Proposal for amendments regarding GRVA-12-52

Modifications to the existing text of UN-Regulation No. 157 are in **bold** for new or ~~strike through~~ for deleted characters.

Model A

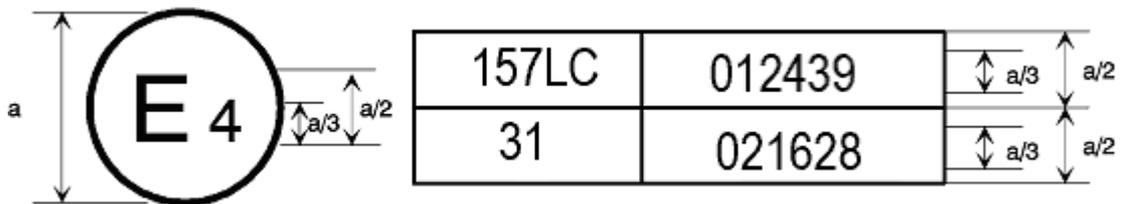
The above approval mark affixed to a vehicle shows that the vehicle type concerned has, with regard to ALKS, been approved in the Netherlands (E4) pursuant to UN Regulation No. 157 under approval No. ~~002439~~ **012439 and is capable of a lane change procedure**. The approval number indicates that the approval was granted in accordance with the requirements of UN Regulation No. 157 ~~in its original version~~ **with the 01 series of amendments incorporated**.
